Memorandum

Date: 12/14/2010

Subject: Revised comments on Energy Fuels' proposed Piñon Ridge uranium mill

Figure 1. Aquifer boundaries near the Piñon Ridge mill. The aquifer extent is bounded on two sides (purple and green lines). Productivity estimates are based primarily on PW-3, PW-4, and PW-5, which are all clustered in the same area.

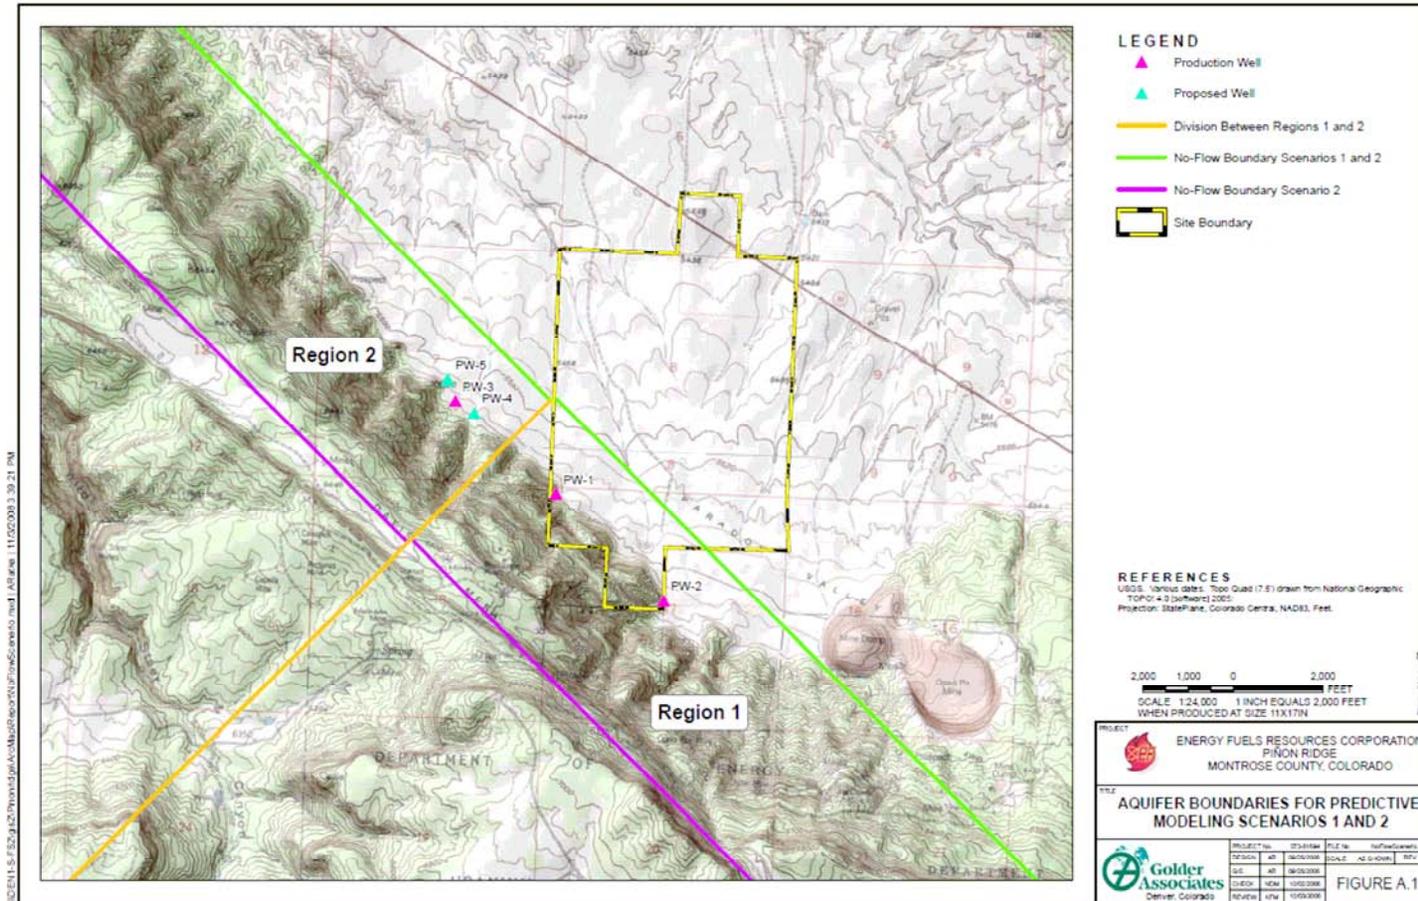
The upper end of the sustainable pumping rate estimate (175 gpm) provided by Golder Associates (2009) assumes generous recharge from Davis Mesa (recharging an aquifer 300–500 ft deep), and it assumes only one boundary restricting aquifer flow. However, as mentioned previously, the aquifer is likely bounded to the northeast by a salt dome and to the southwest by faults in the mesa (Figure 1). When including both of these two boundaries in their calculations, Golder Associates (2008) estimates that only 64 gpm can be sustainably pumped from the aquifer, where sustainability is defined as a five-year period. They did not provide an analysis of the sustainability of aquifer pumping during the subsequent 35 years that the mill is expected to be operating.

With the uncertainty in their data, optimistic assumptions, and no further analysis of water supplies in their recent documents, we do not believe that Energy Fuels and their contractor, Golder Associates, have adequately addressed questions of water supply over the proposed 40-year mill life. It is not unreasonable to assume that this aquifer will provide only a fraction of the non-potable water requirements for the mill. If this is the case, more water will need to be obtained than the proposed 104-gpm contingency water supply from the San Miguel River at Naturita.

As we stated in our previous comments, we recommend that Energy Fuels revise their water supply plan to explore other alternatives if the aquifer is unproductive. This should include a more detailed analysis of the water that Naturita would supply, such as the feasibility of using this water during a drought, particularly if there are more senior water rights holders downstream of Naturita. It should also include a plan for obtaining an additional 40 gpm from another source if the Chinle-Moenkopi wells go dry, and an analysis of the effects of constant truck traffic if the mill uses primarily San Miguel River water. Finally, Energy Fuels should include a temporary closure or other contingency plan in the event that they are unable to obtain the 144 gpm required for operations, including a plan for maintaining water levels in tailings impoundments and evaporation ponds.
